RETREAT AT TIMBERRIDGE FILING NO. 1

CONSTRUCTION DRAWINGS

Engineering Review
05/15/2020 10:27:32 AM
dsdrice
JeffRice@elpasoco.com
(719) 520-7877
EPC Planning & Community
Development Department

18" RCP INLET TO RAIN GARDEN
SCALE 1" = 50' HORIZ.
1" = 5' VERT.

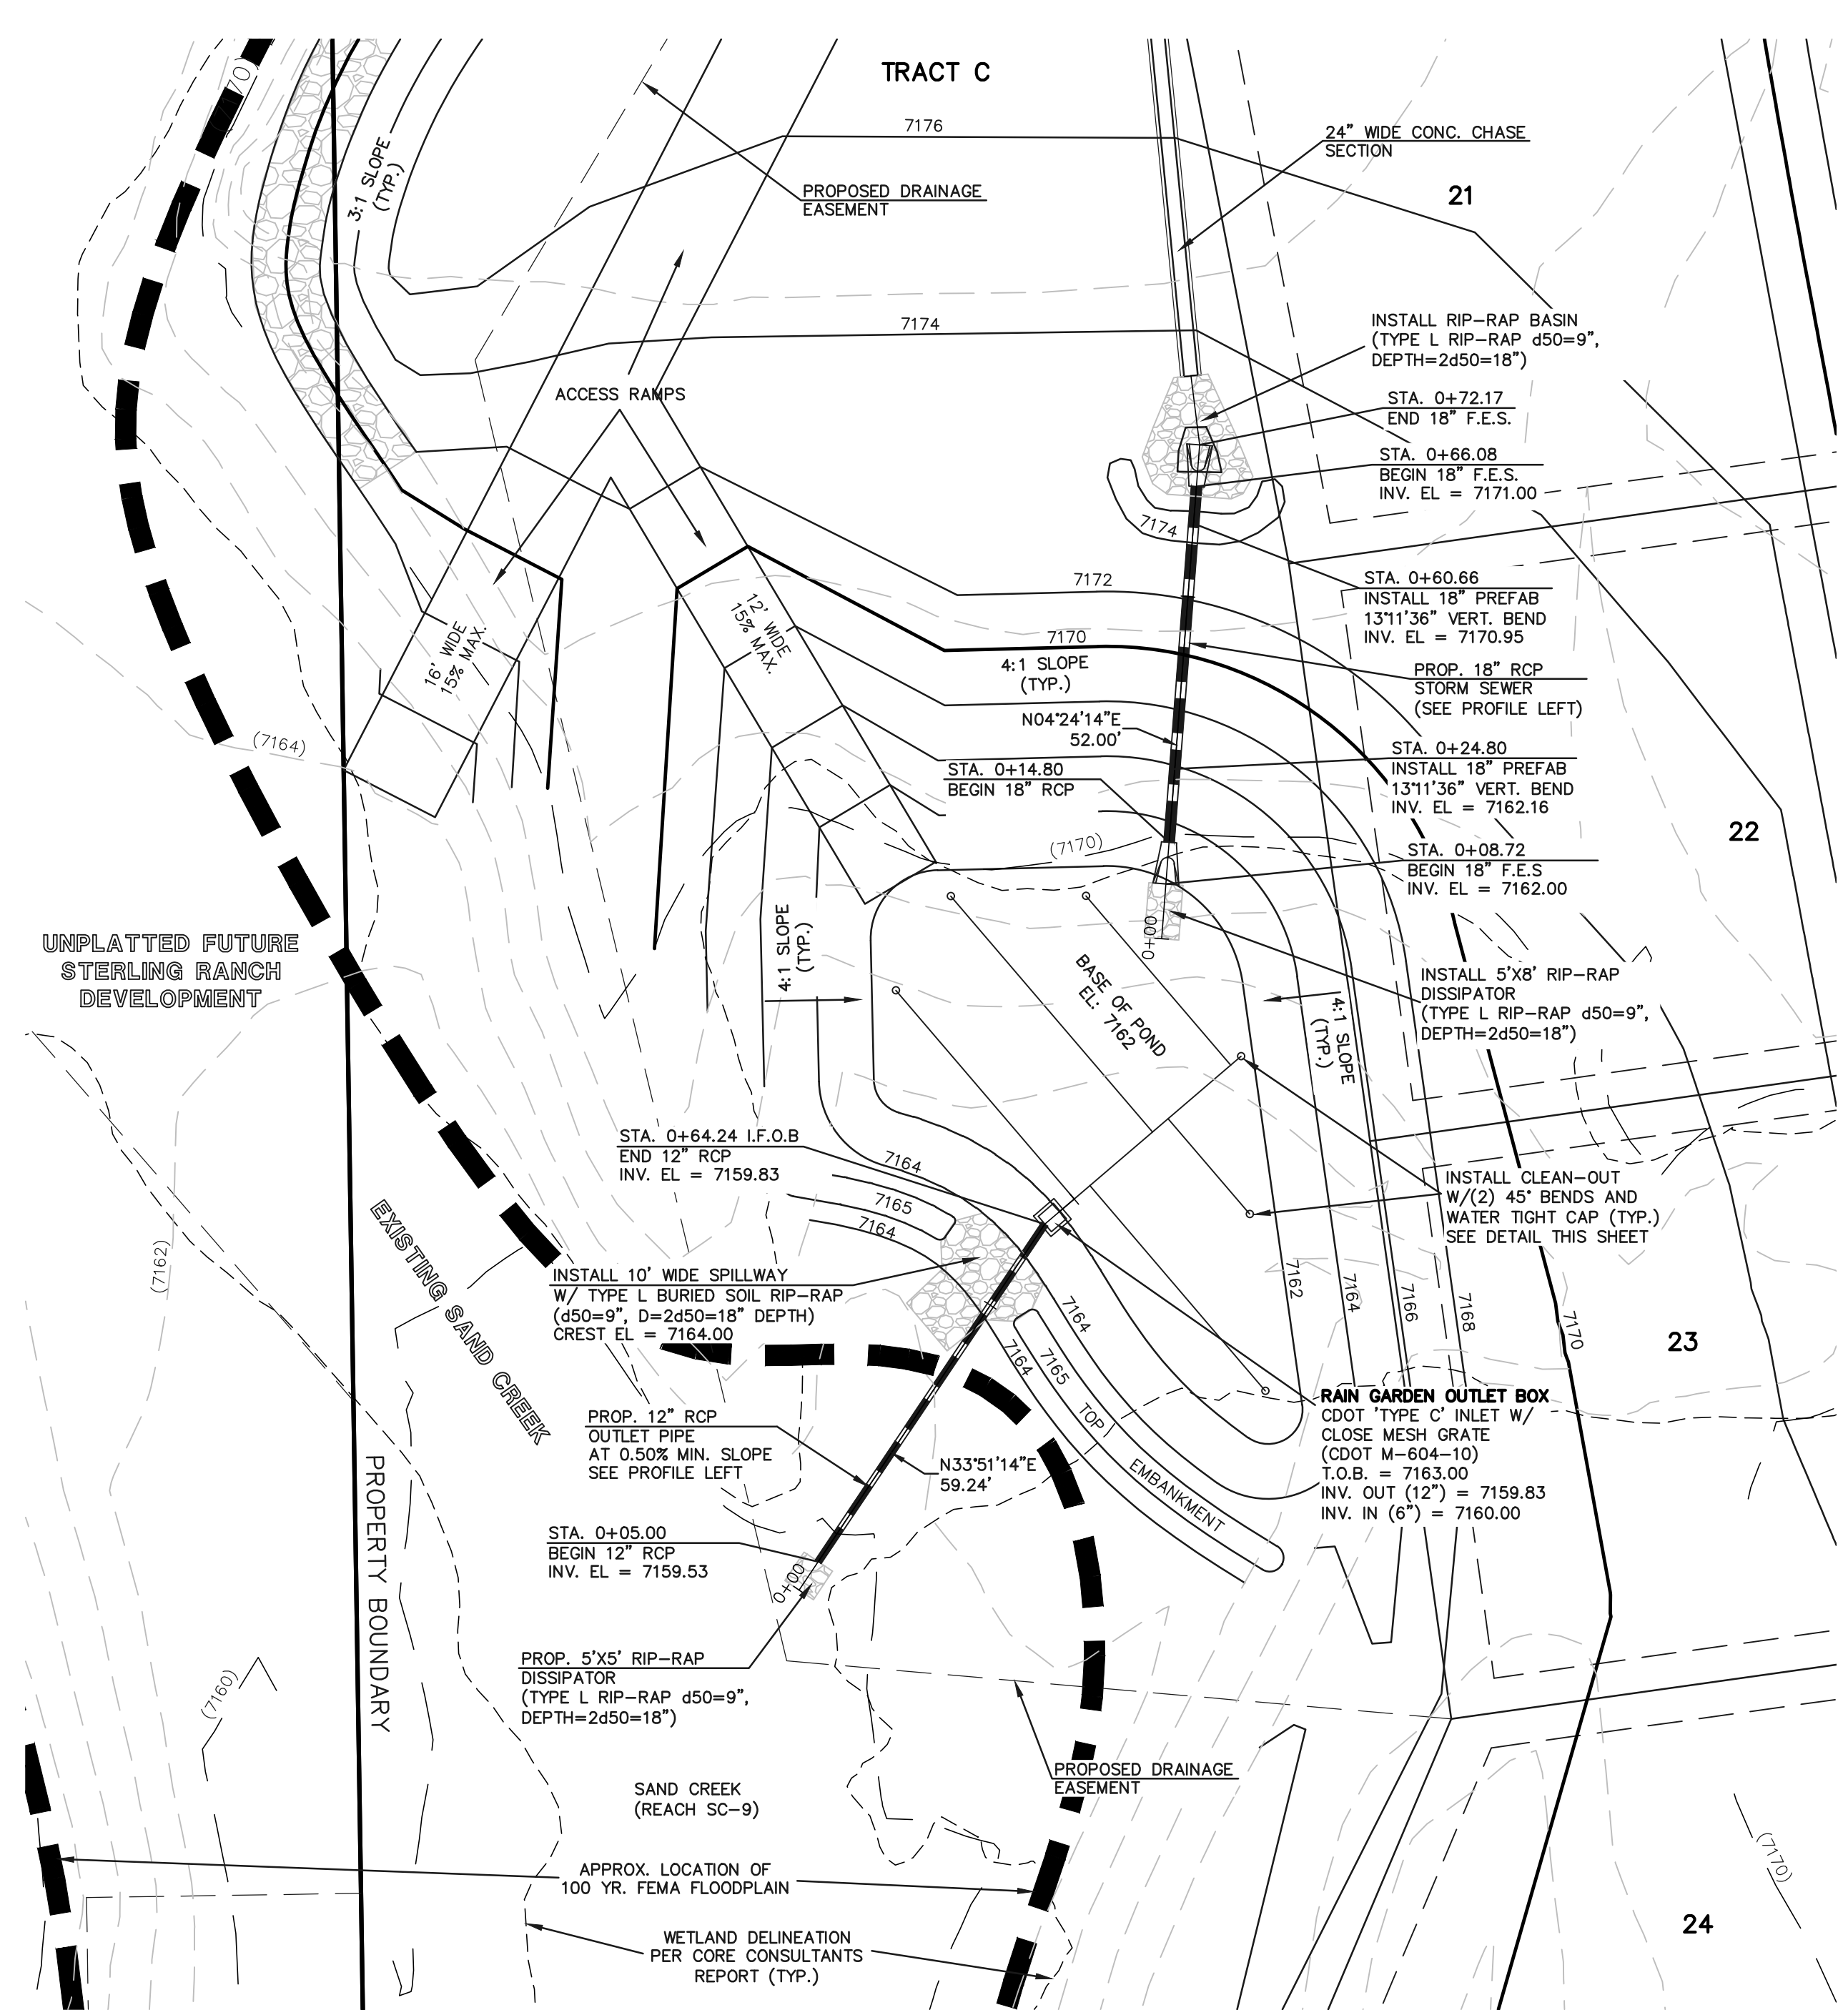
Verify that dissipation will be adequate for velocity exiting pipe.
